The Detroit Edison Company
One Energy Plaza, Detroit, MI 48226-1279

January 10, 2011
NRC3-11-0003

Subject: Detroit Edison Company Response to NRC Requests for Additional Information Letter No. 49

**Response to RAI Letter No. 49
(eRAI Tracking No. 5268)**

Evaluation of Site/Design Parameters and Characteristics (Sheet 4 of 28)

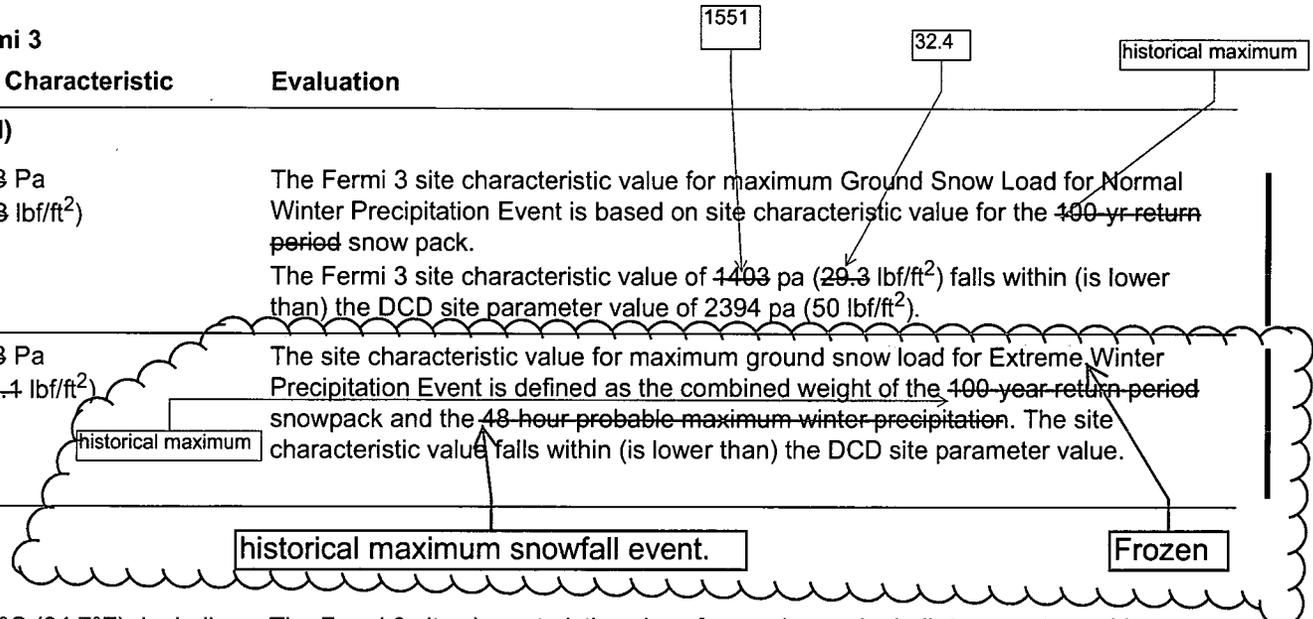
NRC RAI 02.03.01-18

This question is related to the applicant's response to RAI 02.03.01-9 and its incorporation into Revision 2 of the Fermi 3 FSAR.

The last paragraph of Revision 2 to Fermi 3 FSAR Section 2.3.1.3.4.3, "Maximum Roof Load," states that the ESBWR Site Design Parameter extreme winter precipitation event maximum roof snow load is 163.5 psf. The FSAR derives the 163.5 psf value by summing the roof load resulting from the normal winter precipitation event (38.5 psf) and the extreme winter precipitation event (125 psf) values listed in ESBWR DCD Tier 2, Table 3G.1-2. This summation conflicts with the GEH response to RAI 2.3-4 S05 dated May 11, 2009 (ML091320434), which states that the 125 psf extreme live loads for roofs includes the contribution of 38.5 psf from the normal winter precipitation event. Similarly, footnote 5 to ESBWR DCD Tier 2, Table 2.0.1, states the maximum ground snow load for the extreme winter precipitation event (162 psf) includes the contribution from the normal winter precipitation event (50 psf). Please address this apparent contradiction in defining the ESBWR extreme winter precipitation event roof load.

The staff notes that GEH derived its 125 psf extreme winter precipitation event roof snow load by assuming that water from the extreme liquid winter precipitation event will not accumulate above the height of the 2 ft parapet if the roof scuppers and drains are assumed to be clogged. To facilitate a direct comparison with site parameters that are intended to represent ground loads, GEH converted the 125 psf extreme winter precipitation event roof load to an equivalent extreme winter precipitation event ground snow load of 162 psf using guidance provided in ISG-7.

FSAR Section 2.3.1.3.4.3, "Maximum Roof Load" submitted with the response to RAI 02.03.01-9 derived the maximum roof load by summing the roof load resulting from the normal winter precipitation event and the extreme winter precipitation event. Although this methodology yields conservative roof loading results, it is not consistent with the DCD.

FSAR Section 2.3.1.3.4.2 will be updated to reflect the above discussion. The roof loading information in FSAR Section 2.3.1.3.4.3 will be replaced with text that indicates that the maximum roof loading from the Fermi site characteristic maximum ground snow load for normal winter precipitation event and extreme winter precipitation event are bounded by the ESBWR maximum roof snow load design parameters.

As shown in Table 2.0-201, the Fermi site characteristics for the maximum ground snow load for the normal winter precipitation event and for the extreme winter precipitation event are bounded by the Site Parameters in the ESBWR DCD. Therefore, the maximum roof load resulting from the Fermi site characteristic maximum ground snow load for the normal winter precipitation event and extreme winter precipitation event are also bounded by the ESBWR Maximum Roof Snow Load Site Design parameters.
